FIELD INSPECTION

Project Name:	Mountain Valley Pipeline	Inspector:	Marshall Willis
Inspection Date:	Monday, March 11, 2019	Project Contact:	Brian Clauto
Spread I: Franklin County	STA 13853 – 13888 STA 13575 – 13610	Weather (Wet/Dry/Rain):	Dry

FIELD INSPECTION PHOTO LOG

Fig. 1: **STA 13865** – ROW stabilization needed.

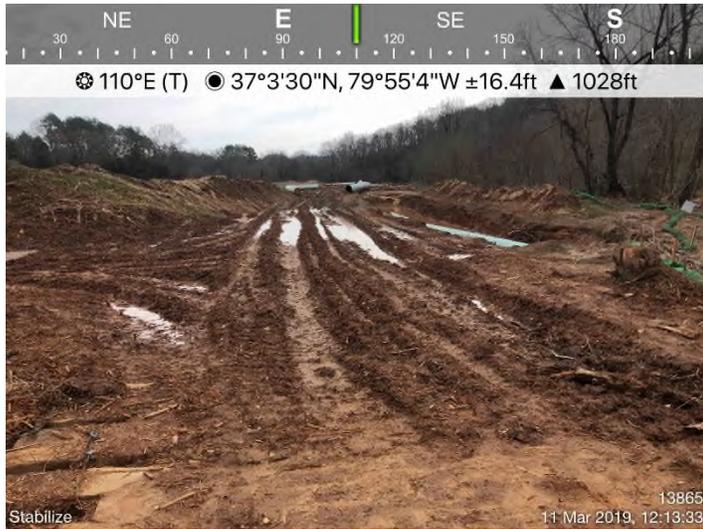
- STA 13863 – STA 13888: Stabilize ROW.
- STA 13879+00: Stabilize stockpiles.
- STA 13576+00: End treatment not installed per project specifications.
- STA 13579: Maintain P1.

Recommended Corrective Action: Maintain and install all controls per the approved plan and specs.
